Attachment 5

**Re. Proposed permit modifications, Michigan Potash Operating, LLC,
MI-133-11-0004, MI-133-11-0005, and MI-133-11-0006**

**—3 Overlapping “AOR’S”
(As defined by the EPA)**

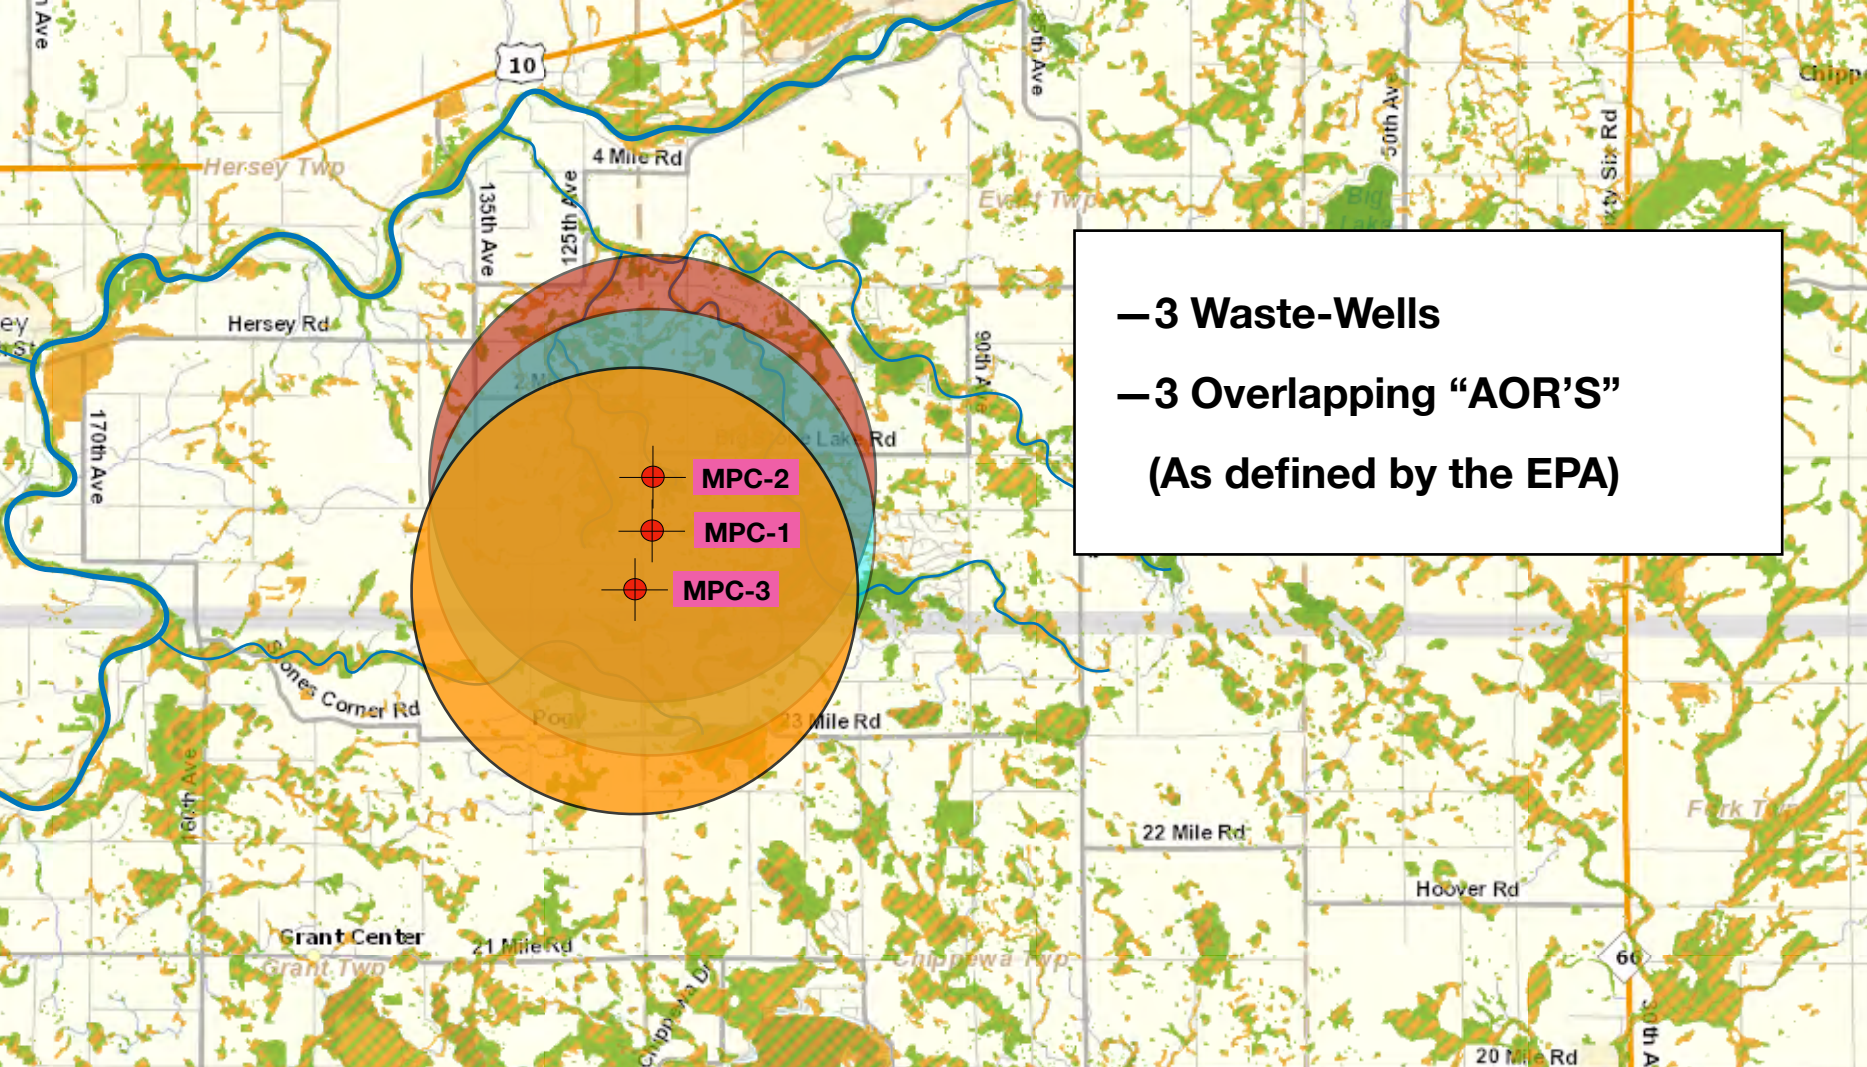
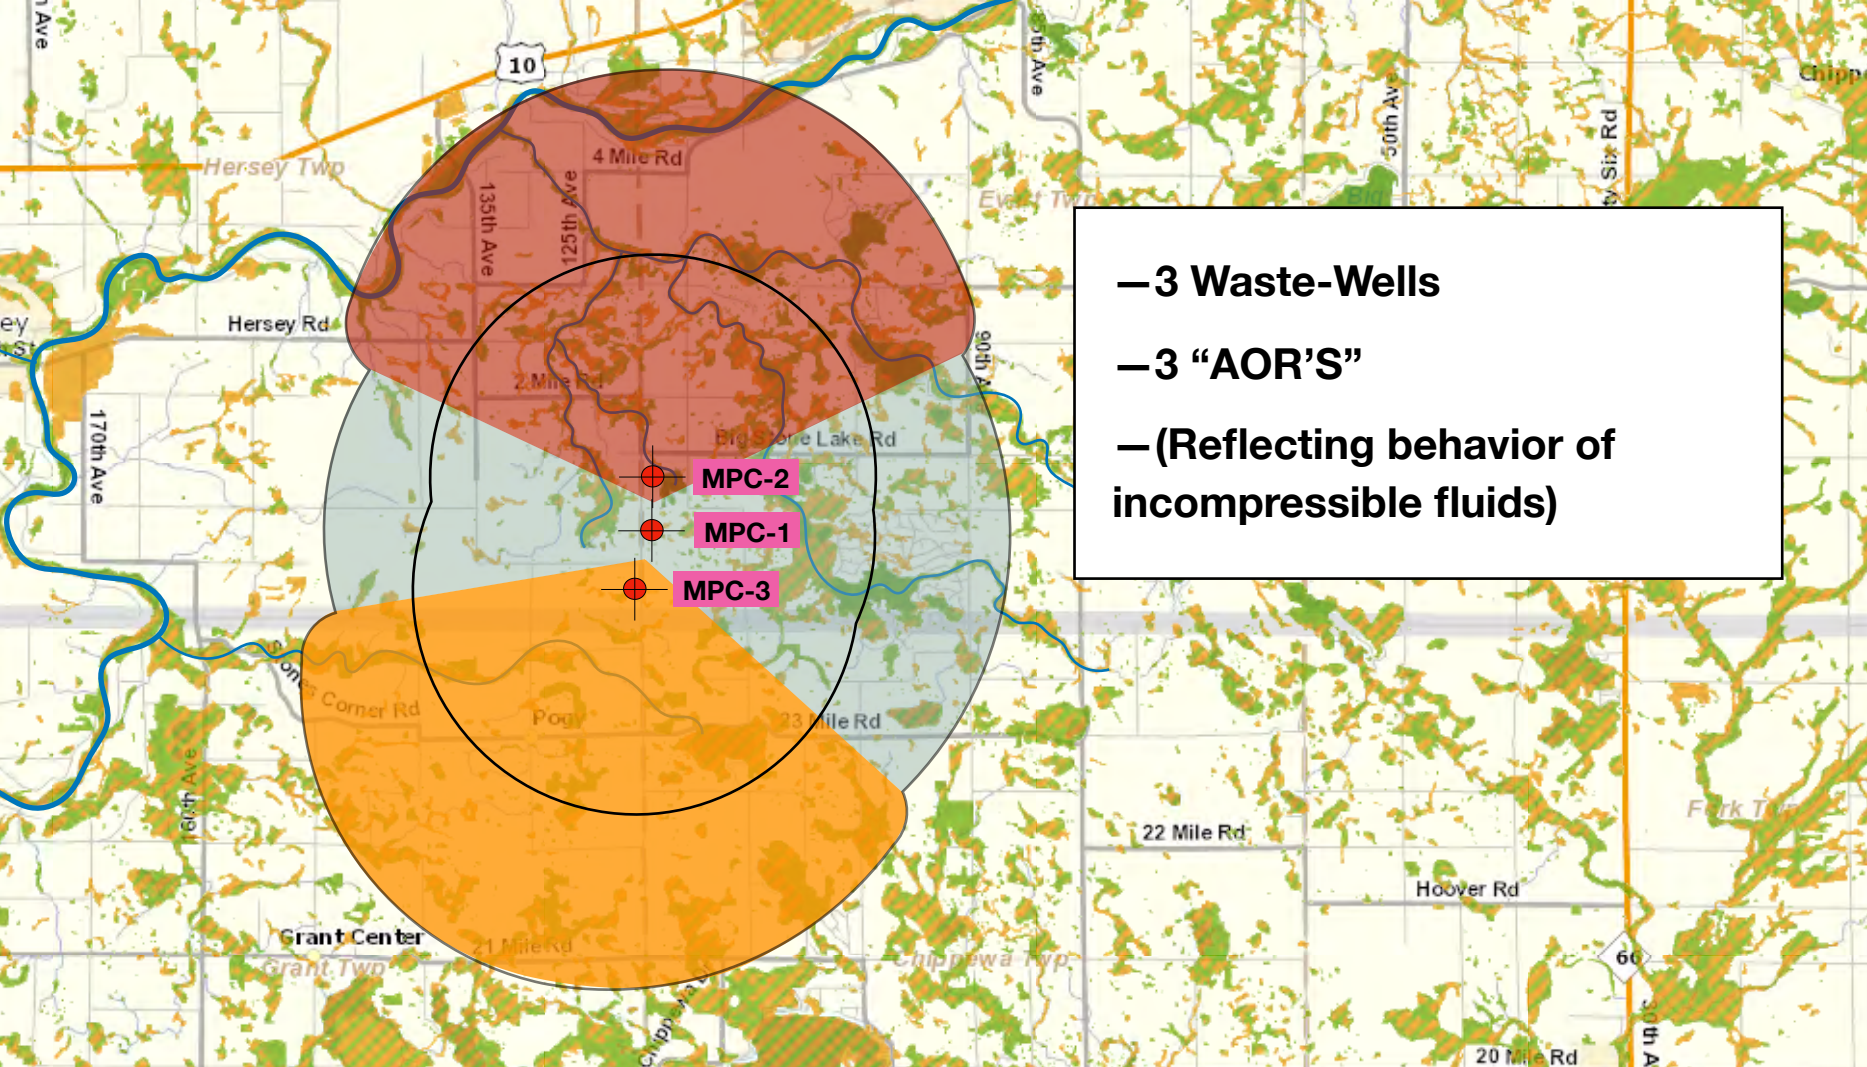
Q: Are these wells being permitted for use only one at a time? If they are intended to be used simultaneously, then I believe there is a serious flaw in your delineation of a combined AOR. Given that the fluids being injected are incompressible, I cannot fathom how those coming from one of these closely-spaced wells will have zero effect on the flow characteristics of fluids injected by its neighbors. Yet that appears to be the underlying assumption for the model you're using here where, for three wells spaced half a mile apart, three circular AOR's were simply piled on top of each other (see drawings below). **In those drawings, I've included what I believe to be a more realistic approximation of what your combined AOR should look like. It's also considerably larger than the one which you are using.**

This error does not make much difference as long as MPSC's wells remain situated below their 900-foot thick confining formation (Detroit River Group) as

currently permitted. This is due to the fact that nearly all of the well-bores existing at that depth are contained within your currently defined AOR. But that is almost assuredly not the case with the more heavily drilled Dundee formation which the company now wants to utilize for its waste-disposal. **For this reason, I urge you to modify the size and shape of your combined AOR accordingly.**
